## D/DRC Case

428 Gervais Street  
Innovista Design District  
TMS: 08912-11-03

**DESIGN/DEVELOPMENT REVIEW COMMISSION**  
**DESIGN REVIEW DISTRICT**  
**April 10, 2014**  
**EVALUATION SHEET**  
**Case #1 Regular Agenda - Urban**

**NATURE OF REQUEST:** Request for Certificate of Design Approval for site and Building Modifications.

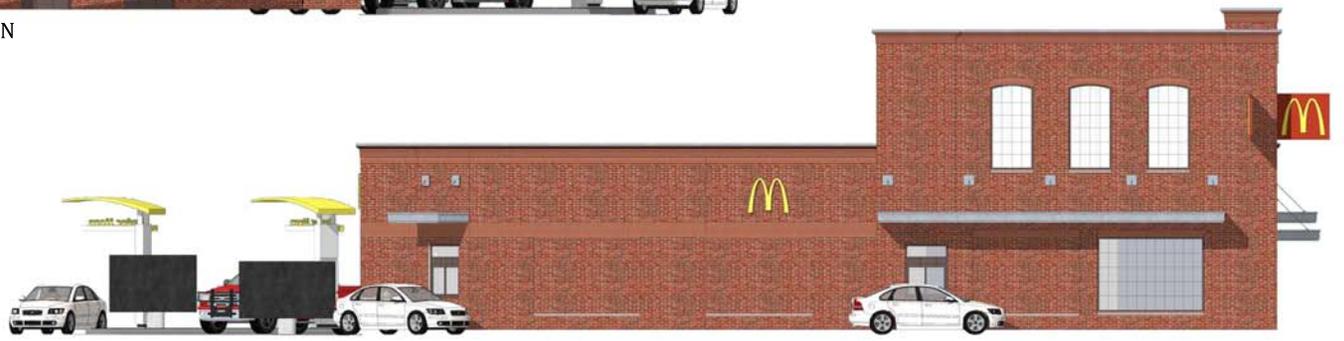
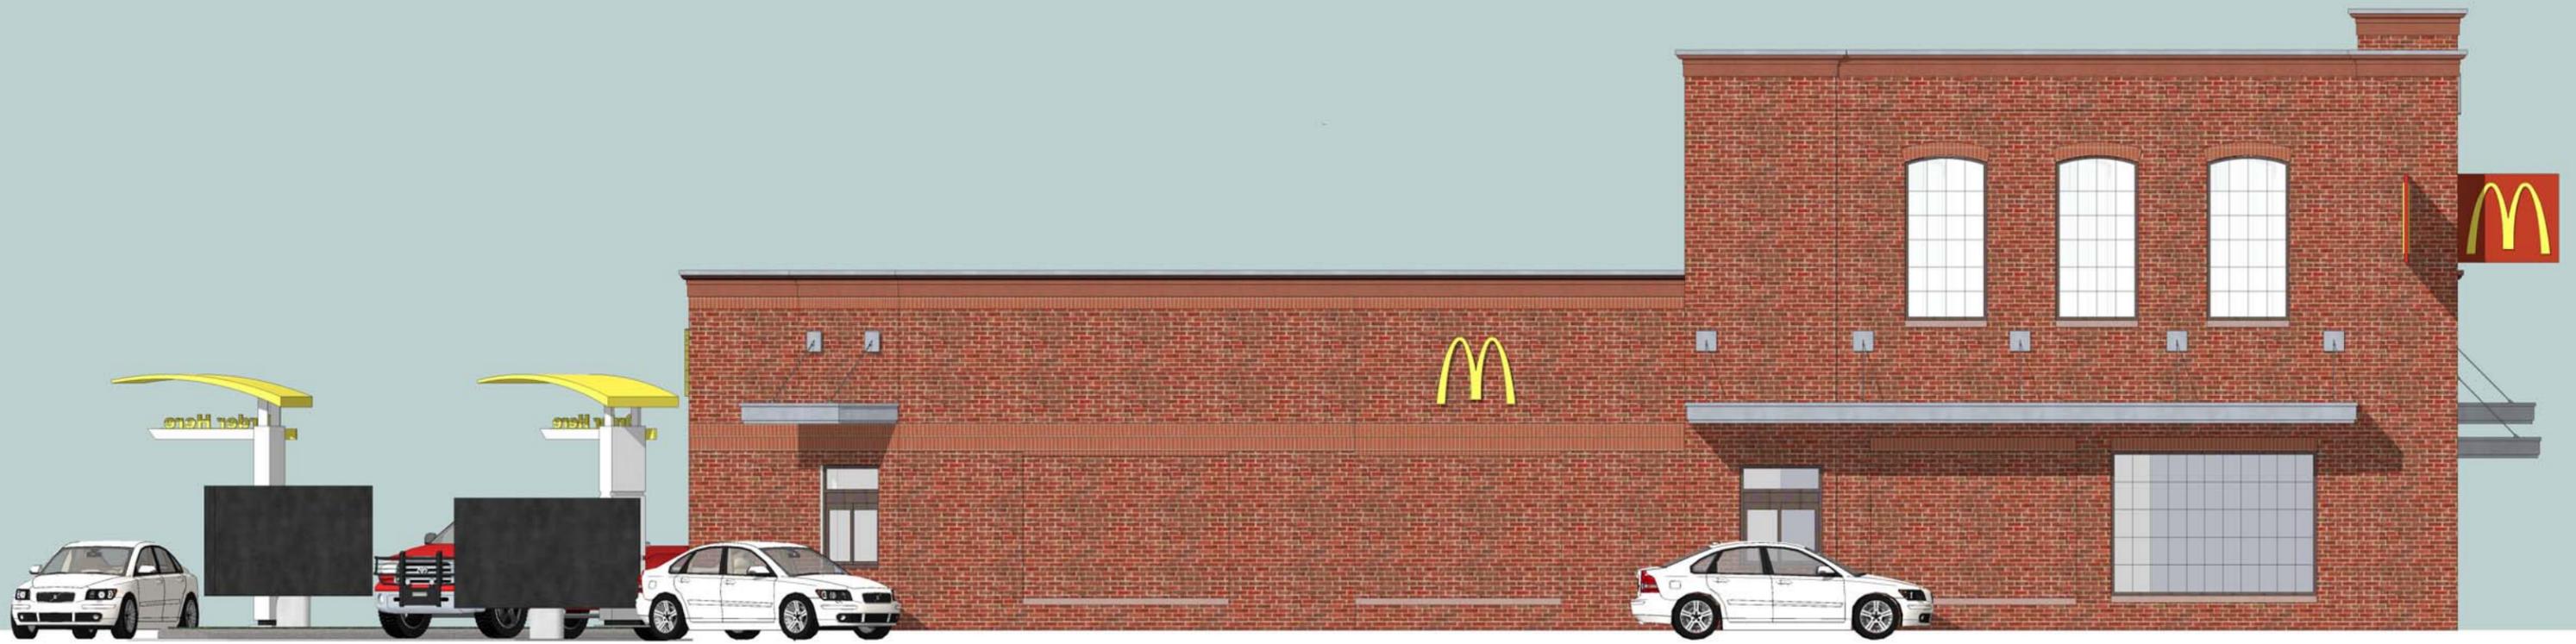
The applicant is proposing to paint existing awnings from a green color to a silver color. In addition they have proposed to add a new entry canopy to match existing with a silver color to be added to the main Gervias Street entry.

Staff has no recommendations regarding this request.
